Potsdam (Germany), the 27th of September 2021

Review of Solid Earth article MS# 2021-63,

The manuscript of Lipus et al., “Dynamic motion monitoring of a 3.6 km long steel rod in a borehole during cold-water injection with distributed fiber-optic sensing” is an article concerning the observation of thermally induced stick-slip events. Cold water pumped into a well causes the rod inserted into the well to contract, with shaking from the stick-slip events recorded on DAS. The results are compared against DAS and DTS data to build a picture of where and why these events are occurring in the well. I think that the results of the paper could be interesting the readership of Solid Earth.

Figure 4_review: Strain differences between DTS and DAS

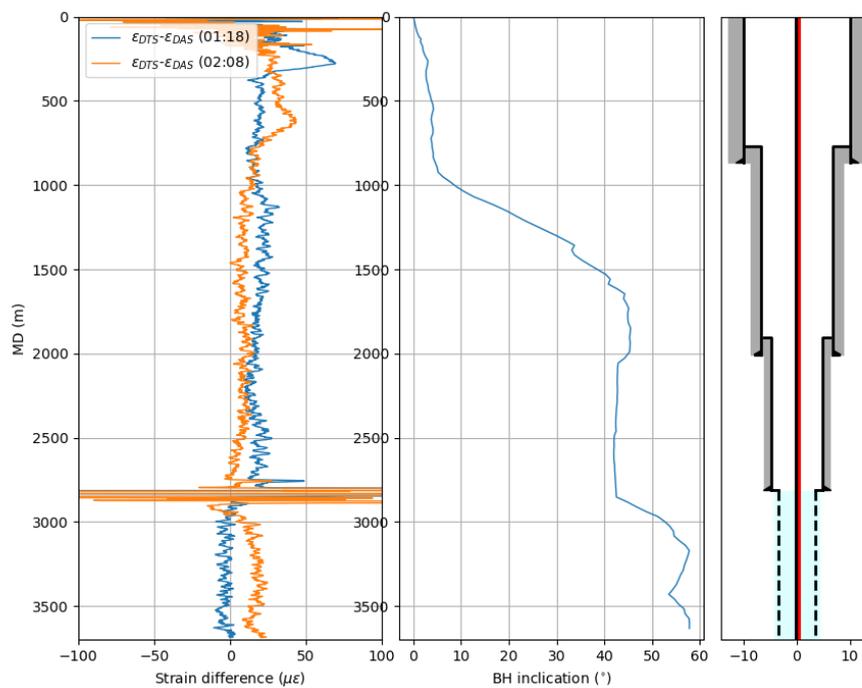
Line 290-295, the difference between strain_DTS and strain_DAS looks relative to the inclination angle. It may be worth to make a figure showing this difference and inclination angle. Adding some discussions about this phenomenon is also useful. Another interesting observation is that difference at 01:18 is larger than the one at 02:08, especially between ~700m and 2800m.

On the 2nd subplot of the Figure 4, the differences between strain_DTS and strain_DAS below the 3100m MD are quite different at 01:18 and 02:08. At 02:08, the strain_DTS is positive while the strain_DAS is close to zero. Such difference is not observed on the data at 01:48. Any clue?

That is an interesting observation. Thank you for pointing this out. Below, we computed the difference for strain_DTS and strain_DAS of Figure 4 (see Figure 4_review). The most prominent apparent relation between strain and borehole inclination is located at the top of the liner, where the inclination strongly increases in a downward direction from an angle of 42° at 2852 m MD to a

value above 50° below 2950 m. This is already discussed in the manuscript. To make this point clearer to the reader, we have added the borehole inclination to the close-up plot in figure 4.

For the remaining differences in the fiber optic strain readings along the well path, we do not see a strong correlation to the borehole inclination.

However, we might make a statement about the strain differences of Figure 4_review with respect to time. The strain difference above 2800 m MD is higher at 01:18, because the cable is stretched to a maximum before the sucker rod events occur. Within the next 50 minutes (until 02:08), the sucker rod events lead to a relaxation of the cable and therefore the strain difference reduces.

Thank you for spotting this. We overlooked this phenomenon in this depth interval. We carefully checked the DTS data and found that for the deeper part of the well (deeper than 3100 m MD), a constant offset in the DTS profiles by about one degree Celsius in subsequent measurements is present. Such offset is not observed in the shallower part of the well. Also, no anomaly is observed in the P/T gauge data from 2750 m MD and no anomaly is observed in the DAS data. We speculate that the temperature anomaly is related to the processing of the DTS data. DTS temperature was measured in a double-ended configuration. A temperature profile is created by overlaying the DTS signal from both directions which are measured consecutively for both fiber branches. Close to the folding location (at the bottom of the well), an asymmetry in the temperature reading was observed between both fiber branches, which does not seem to be caused by any fluid motion. Averaging this difference between both branches led to a temperature offset. This offset was only visible if strong temperature changes were observed in the upper part of the well.
